**Yukon Energy Corporation (YEC)  
2023-24 General Rate Application (GRA)**

**Yukon Utilities Board (Board)  
Information Requests (IRs) Round 1 to  
Yukon Energy Corporation**

Exhibit 3: Proposed Program Staggering

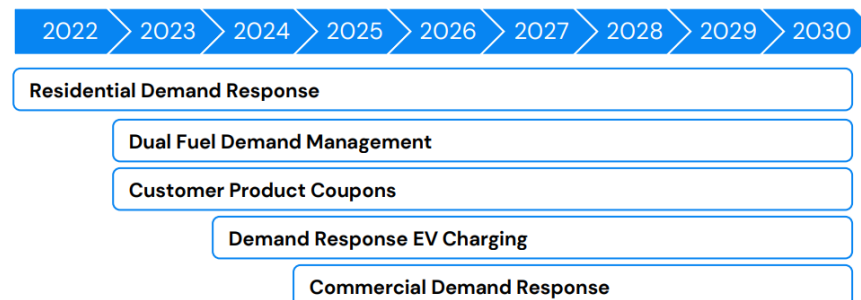
**Preamble:** It is not clear which programs comprise the total forecast costs for each test years' costs on an actual or forecast basis.
